# Japan Comments for GTR22

@EVE57

21. September.2022

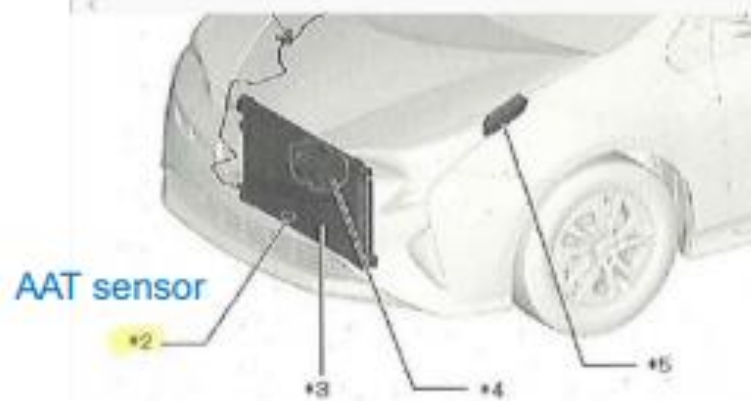
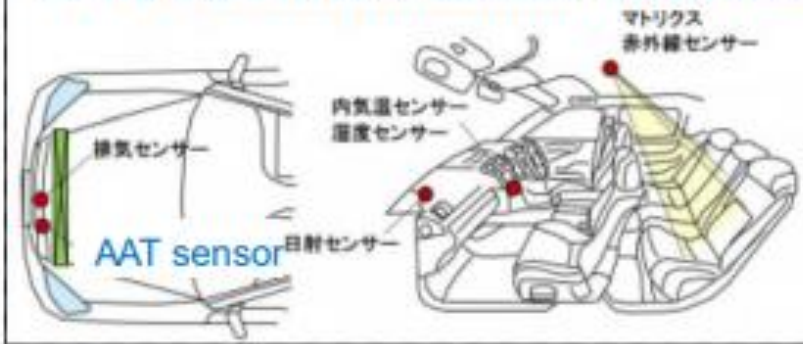
**Considering the additional observations below, Japan proposes:**

If the definition of lifetime includes IG-OFF time,

1. The measurement ECU, CAN-communication ECU, and data storage ECU must be operated at all times (or periodically wake up/sleep) while parked, which requires **\*additional electrical energy** consumption (12 V battery dead, decrease in EV range, etc.).
2. There would be a high possibility of gaining **\*abnormal values and error factors** in measurement during parking. This is because the position of an ambient air temperature sensor (AAT sensor) is often located around the radiator in front of the vehicle in order to accurately measure the ambient air temperature during driving (See page 3.)

<Example of error factors in parking>

effects of direct sunlight, reflection of sunlight from the ground (road surface temperature), exhaust gas from other vehicles, snow, freezing, etc.

## Sensor locations for Air Condition Control ECU

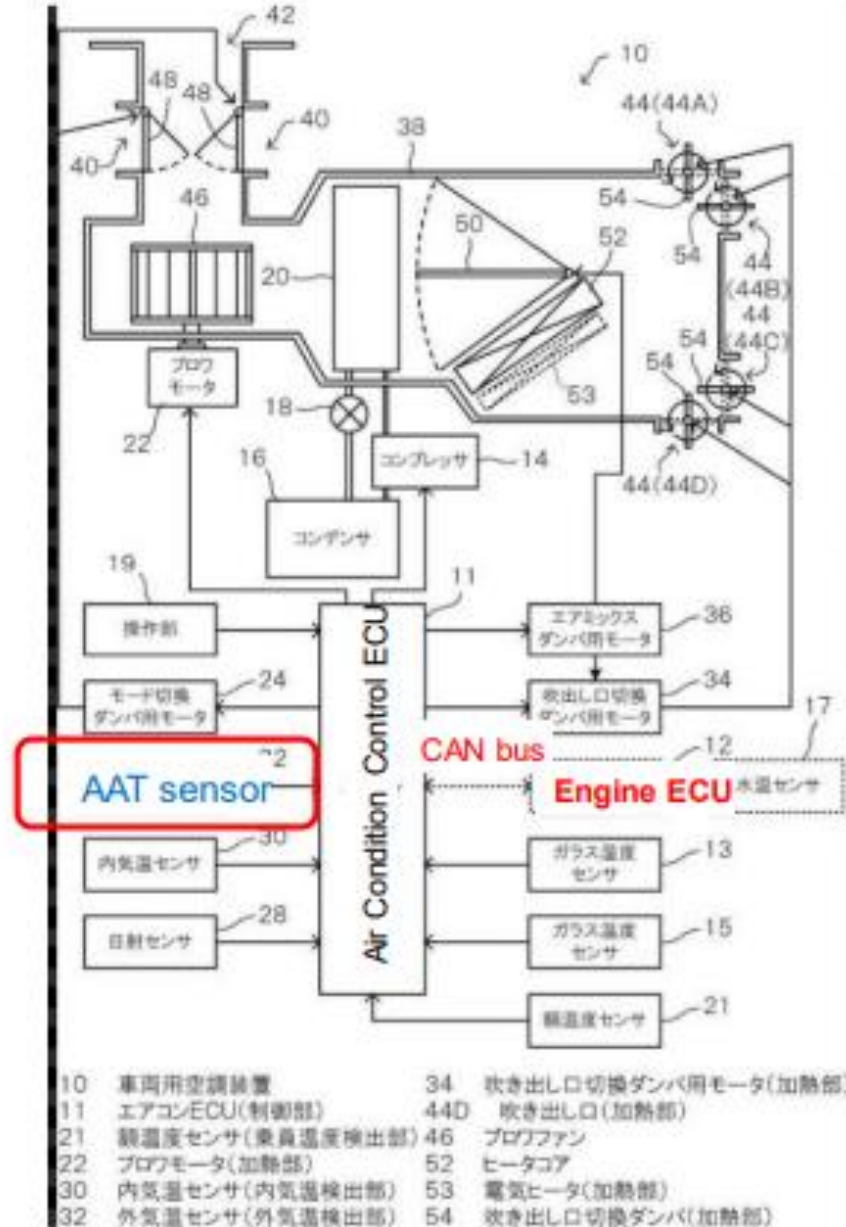
軽行プリウスやアクア、クラウンなどはフロントバンパーの裏側に取り付けられている。2番が内気温センサー（サーミスタASSY）、3番がクーラーコンデンサーASSY、4番がモーター

マトリクス赤外線センサーはフロントバンパー裏側に取り付けられている
